MEMORANDUM

Re: **Montgomery Place, LLC**
Amended Preliminary/Final Major Site Plan – Building #2
County Club Meadows, LLC
Block 5023, Lots 2 and 3
BMPUD Belle Mead Planned Unit Development

Date: January 21, 2022

RE: Montgomery Place, LLC
Pike Run Plaza, Retail Building #2
**Amended Preliminary and Final Site Plan
Variance Plan
Application #PB-04-21
Engineering Review #2**
2311 US Highway 206
Block 5023, Lot 2 and 3
Township of Montgomery
Somerset County, New Jersey

Figure 1 - Building Identification Plan

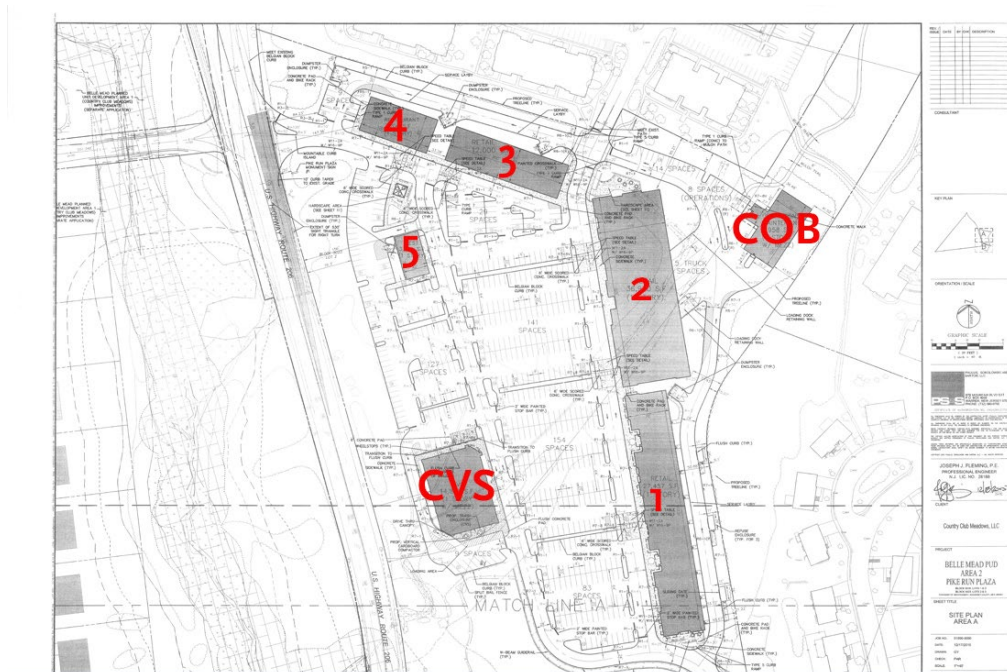
- 1.4 In order to easily discuss compliance of the various buildings, this office has identified the buildings as follows and shown on Figure 1 below. Building 2 is the subject of this review memorandum only. Information pertaining to Buildings 4 and 5 has not been submitted at this time. Prior to the issuance of building permits, the applicant must obtain final site plan approval for Buildings 4 and 5.
